Thank you for the Conservation Law Foundation's (CLF) comments on the Notice of Intent (NOI) submitted to the U.S. Environmental Protection Agency (EPA) Region 1 for coverage under the Massachusetts Small Municipal Separate Storm Sewer System General Permit (MA Small MS4 General Permit). On November 19, 2018, we received your comments pertaining to the NOI submitted by the Massachusetts Development Finance Agency (Mass Development) for the Devens Regional Enterprise Zone (Devens).

Re: Notice of Intent for Devens, MA to be covered under the National Pollutant Discharge Elimination System Small MS4 General Permit – Response to Conservation Law Foundation Comments

Attachments

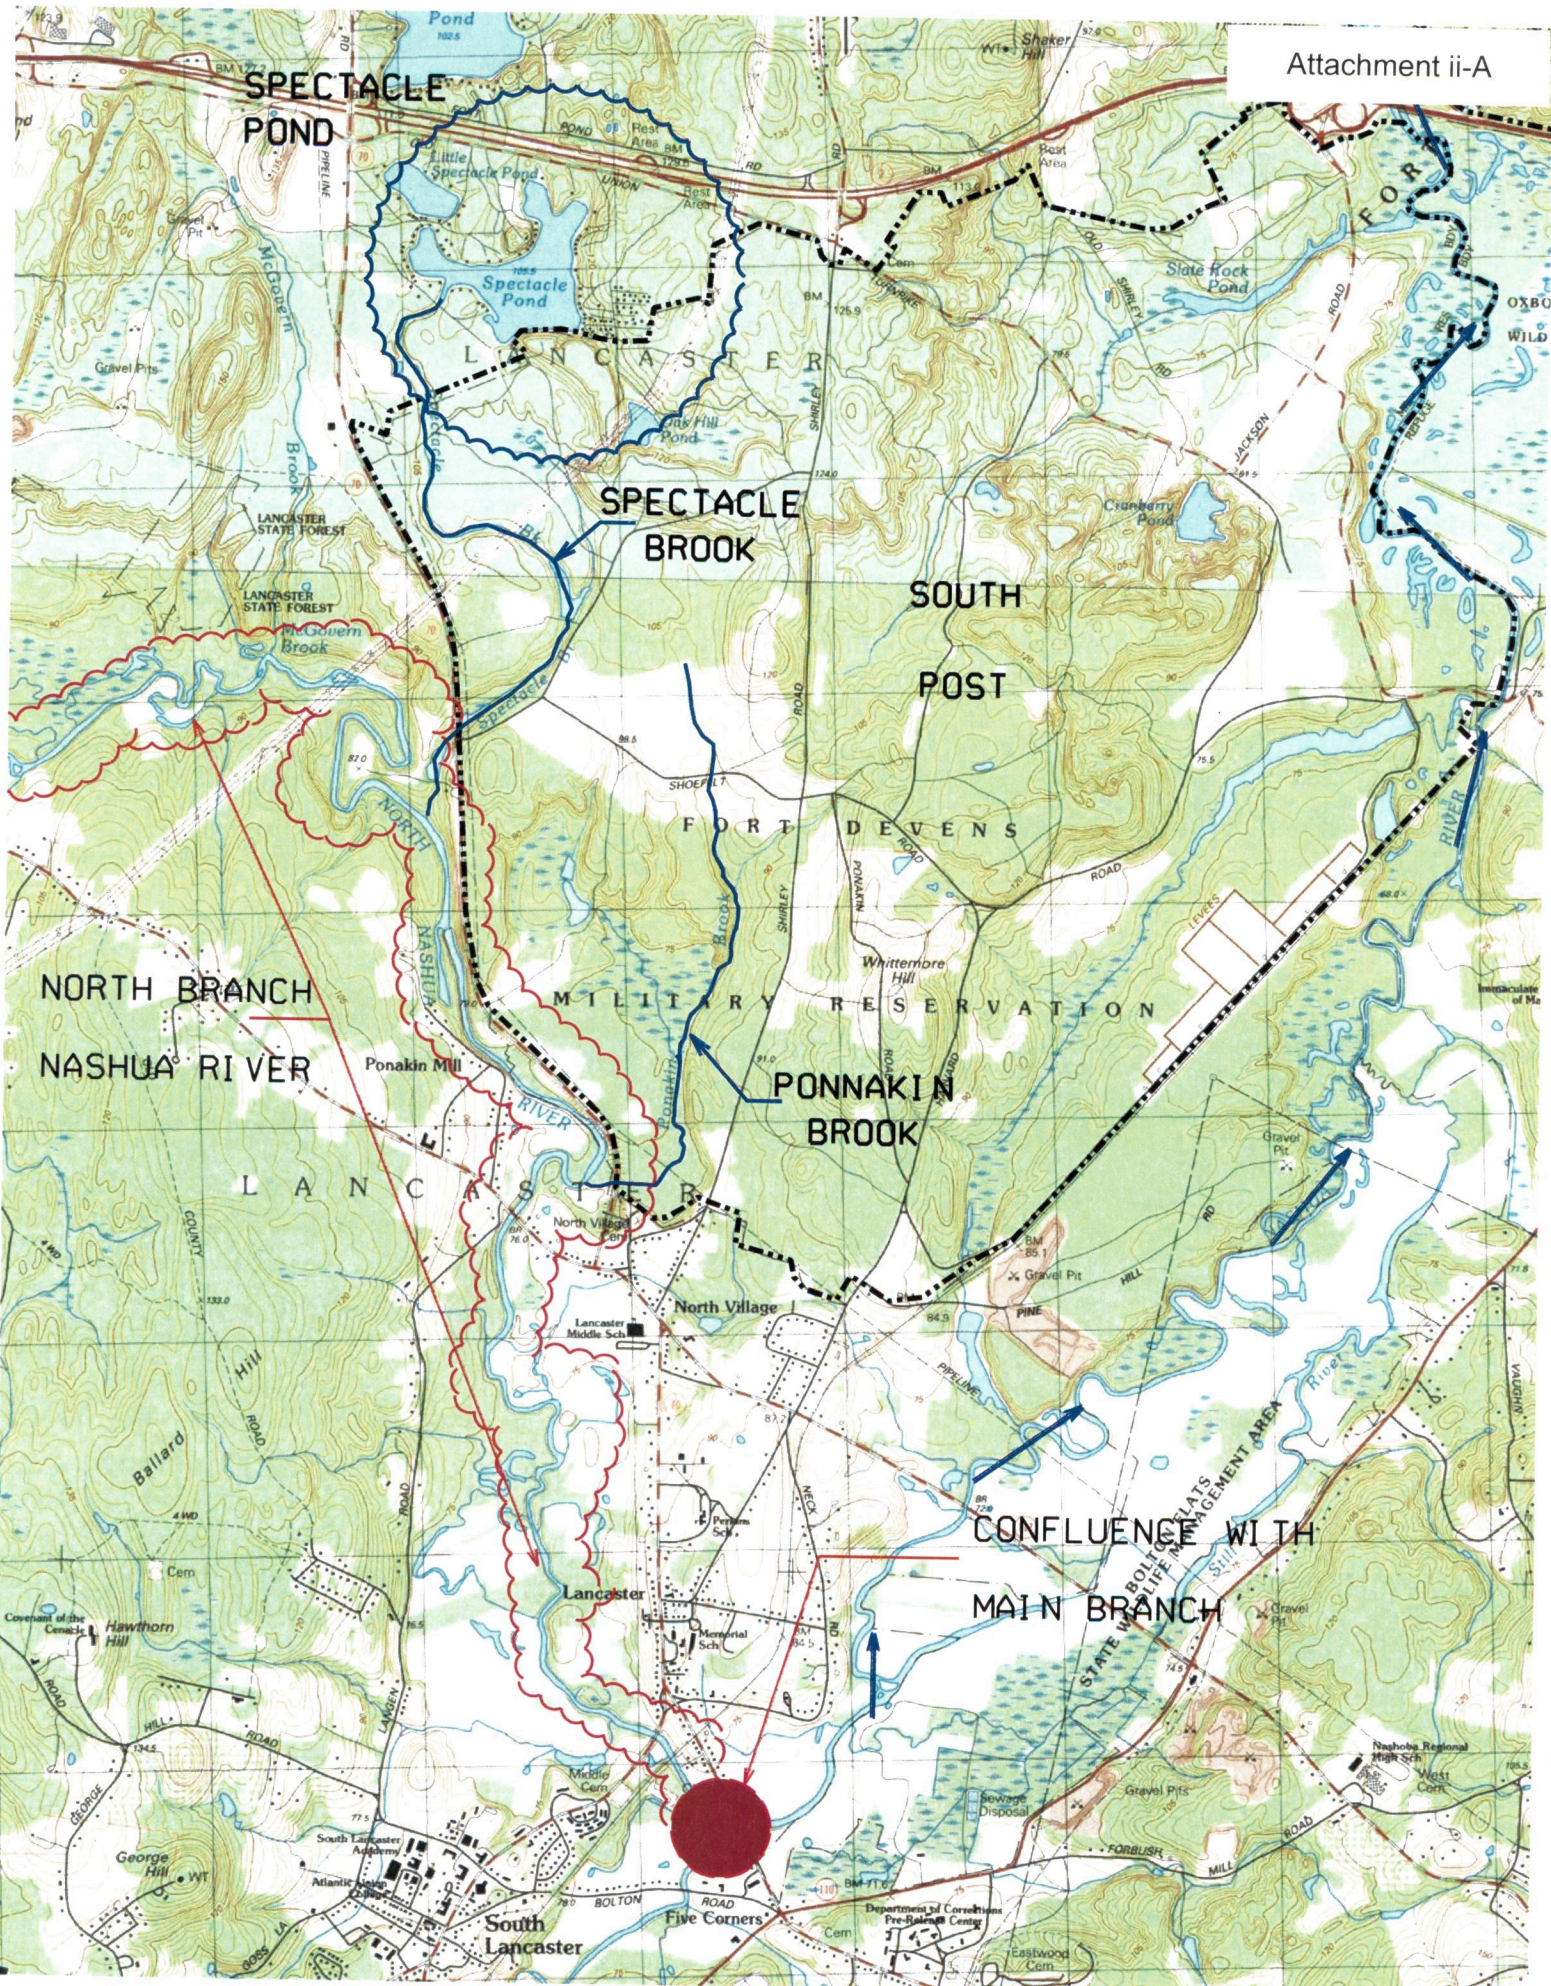
- a. **Nashua River North** (MA81-04) – The north branch of the Nashua River flows from the Leominster area and joins with the main branch in South Lancaster. The confluence is upstream of the portion of the Nashua River which flows through the DREZ. A portion of the North Branch flows along the boundary of the South Post of Fort Devens. However, the South Post is under the jurisdiction of the Department of Defense. (See Attachment ii-A)

- e. **Spectacle Pond** (MA 81132) – Spectacle Pond is located at the western edge of South Post, but the Devens municipal stormwater system is not hydraulically connected to this pond. Spectacle Pond discharges to the North Branch of the Nashua River upstream from Devens (See Attachment ii-A).

- h. **Little Mirror Lake** – There are no known point discharges to Little Mirror Lake.
- i. **Spectacle Brook** – Spectacle Brook is located at the western edge of South Post and flows from Spectacle Pond to the North Branch of the Nashua River. The Devens municipal stormwater system is not hydraulically connected to this brook. (See Attachment ii-A).

- j. **Ponakin Brook** - Ponakin Brook is located at southern edge of South Post and flows from Spectacle Pond to the North Branch of the Nashua River. The Devens municipal stormwater system is not hydraulically connected to this brook. (See Attachment ii-A).
